Comunicazione di Cambio Prodotti

EA – EAM 36 F/G

Product Change Notification

EA – EAM 36 F/G

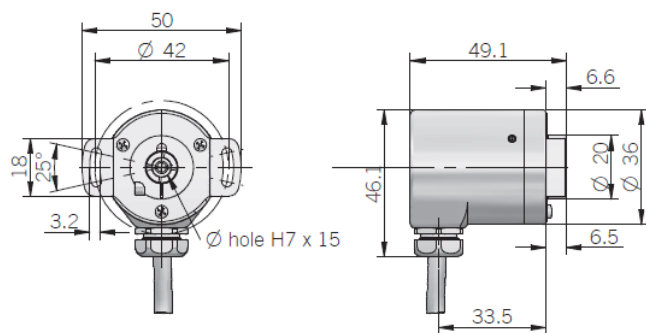
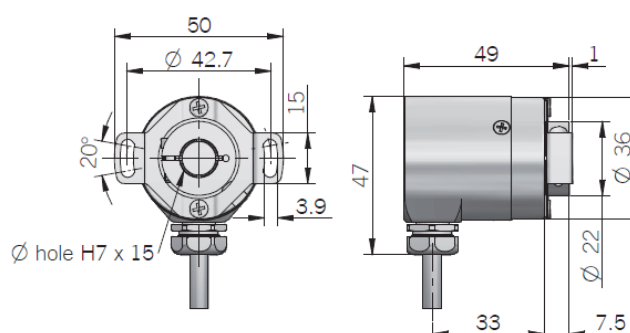
Aumento 1mm altezza totale mod.F, presenza di boccola di riduzione (per diametro albero diametro diverso da 10mm e 9,52mm (3/8"))

Precedente ingombro mod.F

Nuovo ingombro mod.F

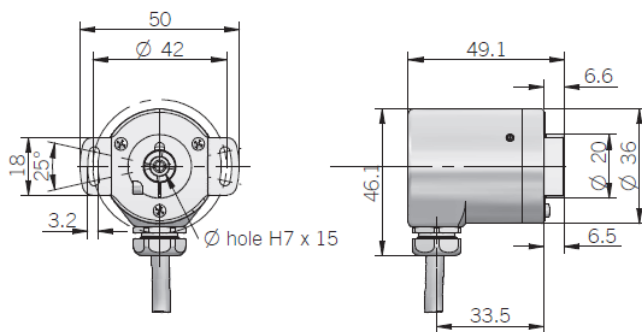
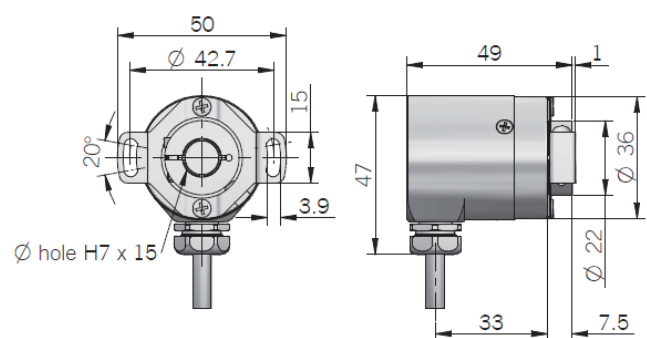
Increase of 1mm total height on mod.F, adapter shaft included (for shaft diameter different than 10mm or 9.52mm (3/8 ”))

Mod. F previous dimensions

Mod. F new dimensions
